# UNITED STATES PATENT AND TRADEMARK OFFICE

APPLICATION NO.	FILING DATE	FIRST NAMED INVENTOR	ATTORNEY DOCKET NO.	CONFIRMATION NO.
10/757,928	01/15/2004	Joseph Huang	ALTR:023	6328

**Office Action Summary**

## **DETAILED ACTION**

With regard to **claim 9**, Fuchigami discloses an integrated circuit (**see figure 1, annotated below for at least claims 9-29**), comprising:

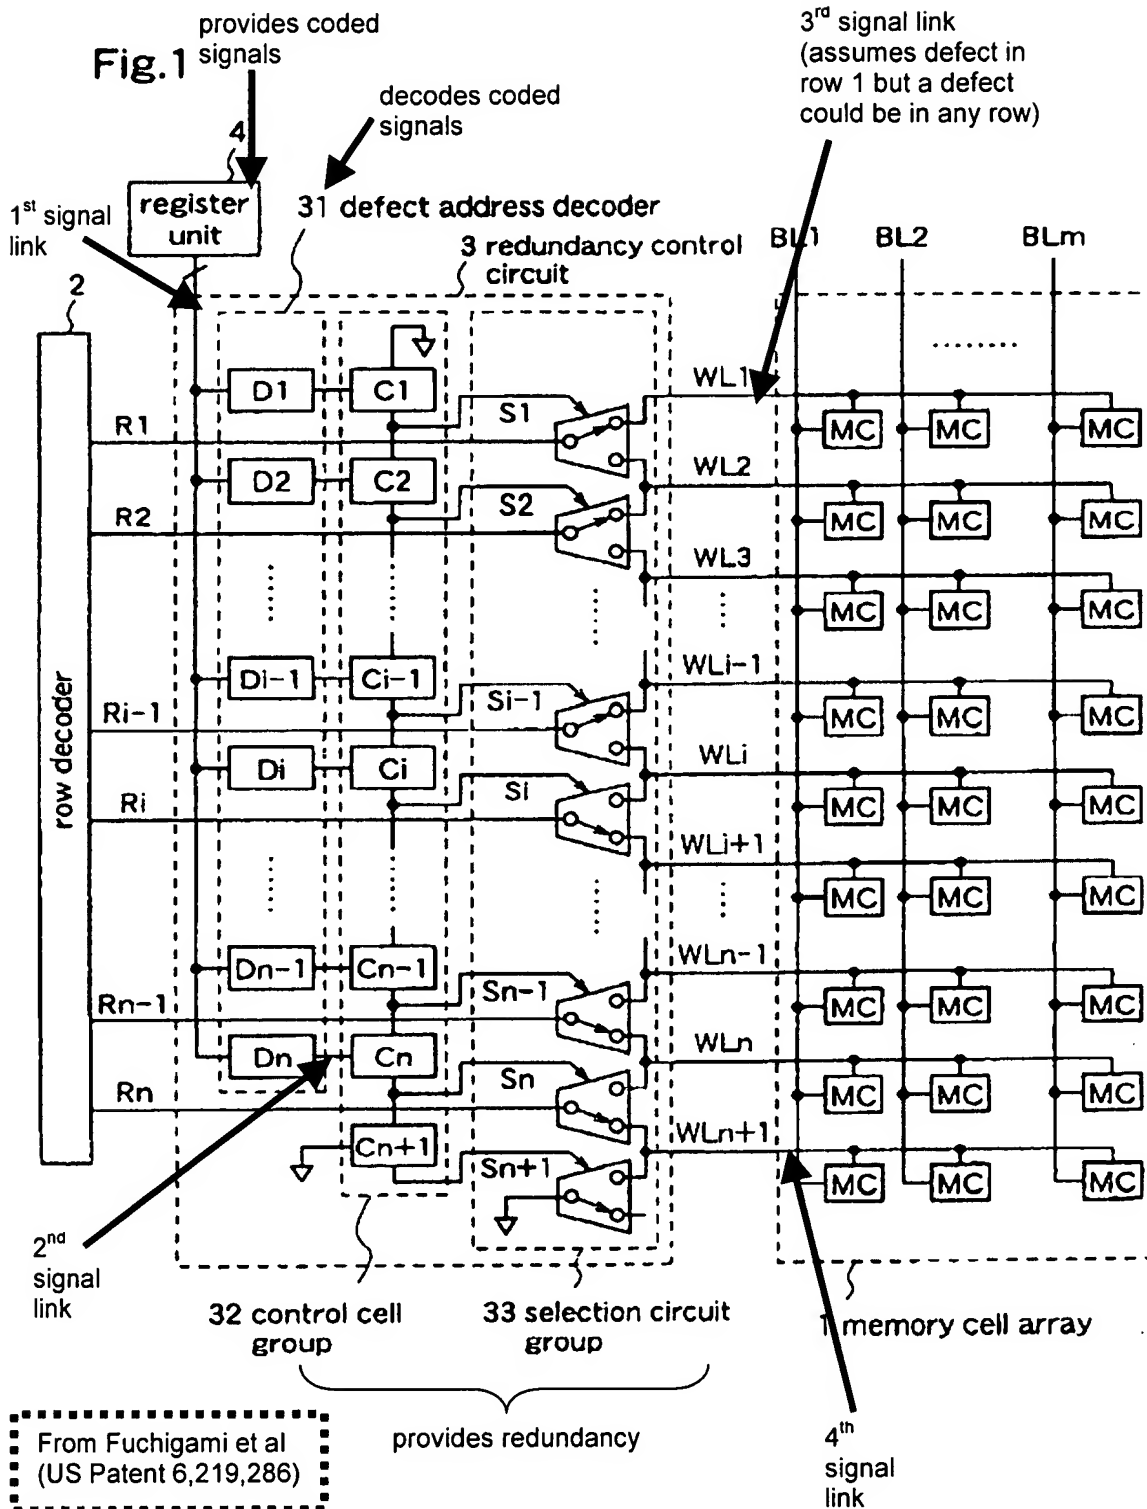
means 4 for providing coded signals that correspond to a defect in a defective circuitry within the integrated circuit (abstract);

means 31 for decoding the coded signals to generate decoded defect signals (abstract); and

means (32 and 33) for providing redundancy in the integrated circuit in response to the decoded defect signals (abstract).

a plurality of programmable elements 4, the plurality of programmable elements configured to provide a first set of signals (through 1<sup>st</sup> signal link as illustrated);

a decoder circuit 31 coupled to the plurality of programmable elements 4, the decoder circuit configured to derive a second set of signals (through 2<sup>nd</sup> signal link as illustrated) from the first set of signals; and

redundancy circuitry (32 and 33) coupled to the decoder circuit, wherein the redundancy circuitry is responsive to the second set of signals (abstract).

With regard to **claim 21**, Fuchigami discloses a programmable logic device (PLD) according to claim 20, further comprising a redundant circuit ( $WL_{n+1}$  where  $n$  is the row number of the row with a defect), wherein, in response to the second set of signals (through 2<sup>nd</sup> signal link, the redundancy circuitry causes an input signal to be coupled to the redundant circuit instead of the defective circuit.
